Rezoning Transportation Analysis

Petition Number: 2022-210

Revision Log:

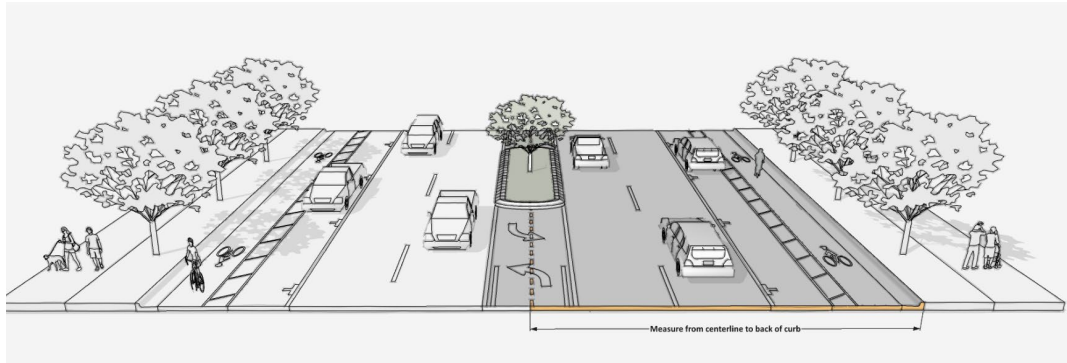
- a. ~~**South Tryon Street:** Location of curb and gutter to be moved a minimum of 42.5 feet from roadway centerline to accommodate the Charlotte Streets Map with a roadway typical section of a 4+ Avenue with Buffered/Separated Bike Lanes and On-Street Parking.~~

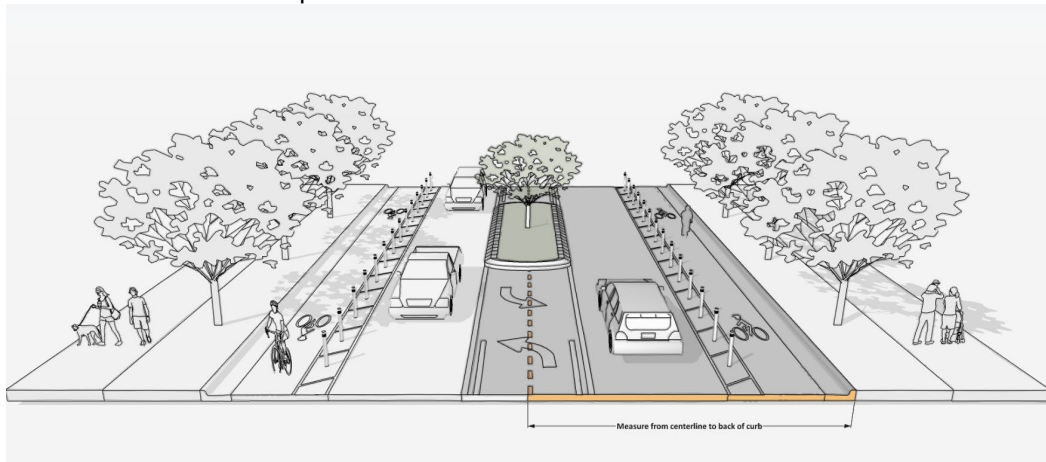
- b. ~~Clanton Road: Location of curb and gutter to be moved a minimum of 27 feet from roadway centerline to accommodate the Charlotte Streets Map with a roadway typical section of a 2+ Avenue with Buffered/Separated Bike Lanes.~~

NOTE: Additional distance from center line to back of curb may be required in locations where a median and turn lanes are required. Final curblines to be reviewed by CDOT once TIS is approved.

Outstanding Comment 9.20.23: Label and dimension the curb and gutter from the centerline for each road on the site plan.

Clarifying comment 6.21.23: Label and dimension the curb and gutter from the centerline for Clanton Road and South Tryon Street.
